**SHEARON HARRIS NUCLEAR POWER PLANT, UNITS 2 AND 3  
DOCKET NOS. 52-022 AND 52-023  
RESPONSE TO REQUEST FOR ADDITIONAL INFORMATION LETTER NO. 019 RELATED TO  
STABILITY OF SUBSURFACE MATERIALS AND FOUNDATIONS**

**Shearon Harris Nuclear Power Plant Units 2 and 3  
Response to NRC Request for Additional Information Letter No. 019 Related to  
SRP Section 02.05.04 for the Combined License Application, dated September 25, 2008**

**NRC RAI #:** 02.05.04-1

**NRC RAI #:** 02.05.04-2

FIGURE A-3

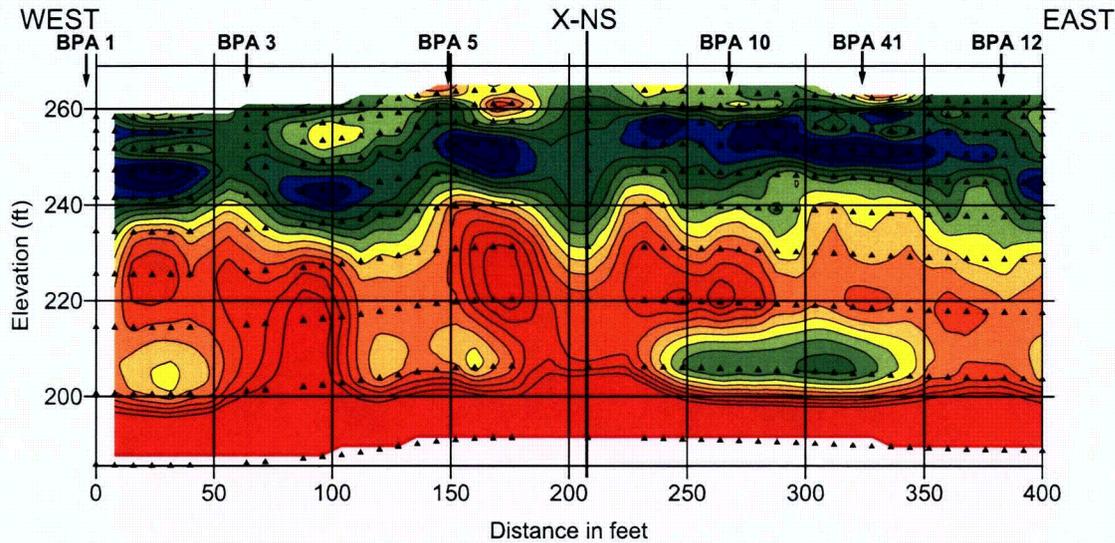
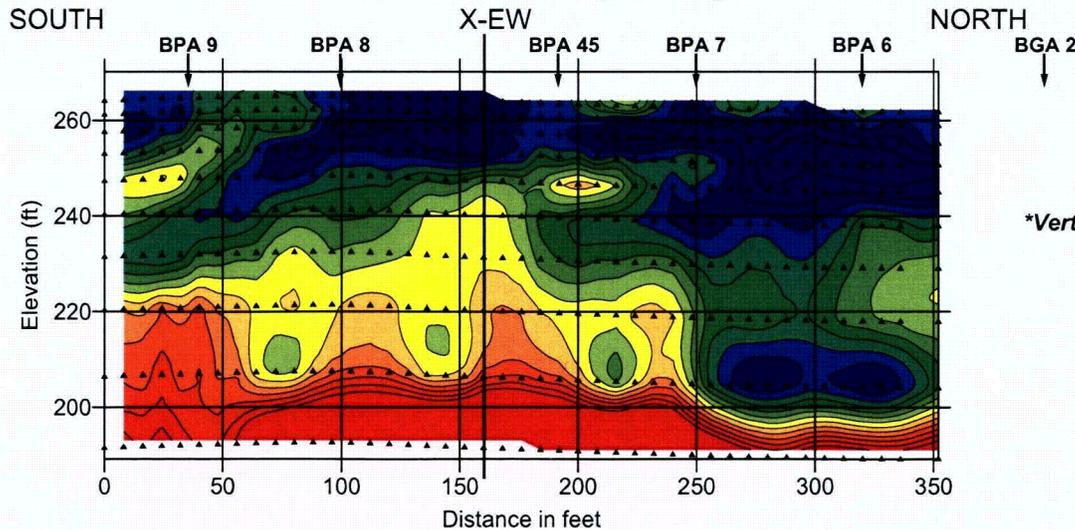
In Section 2.5.4.4.1.7, you stated that "Upon review of the MASW survey results,  $V_s$  interpreted by this method are not consistent with results from other methods, and the method is not considered representative of the HAR 2 and HAR 3 subsurface materials. The MASW results are therefore not further considered in this FSAR". Please provide a detailed assessment of why the results obtained by this method should not be considered representative of the subsurface structures beneath the nuclear islands. Explain apparent problems that might have occurred during data collection and/or data processing.

- The locations of boreholes BPA-6 and BPA-7 are shown along the MASW profile on Figure A-3. No supplemental  $V_s$  data from other methods are available at these locations. As shown on Figure A-3, a  $V_s$  inversion is indicated commencing north from BPA-7 and extending past BPA-6, between approximate elevation 195 and 215 feet. The MASW data indicate that the low  $V_s$  within this interval is less than 1800 fps. Review of the BPA-7 borehole log does not indicate any features (low RQD or recovery, clay seams, etc.) that would support such an inversion in this elevation range. The BPA-6 borehole log shows some reduction of RQD in this elevation range, but nothing to indicate such a low  $V_s$ . Deeper weathered rock and soil intervals encountered at BPA-6 (especially between elevation 160 and 175 feet) are below the depth extent of the MASW investigation.

inversions seen in the upper 20 ft bgs for the MASW profiles at HAR 2 (Figures A-3, A-5, and A-6).
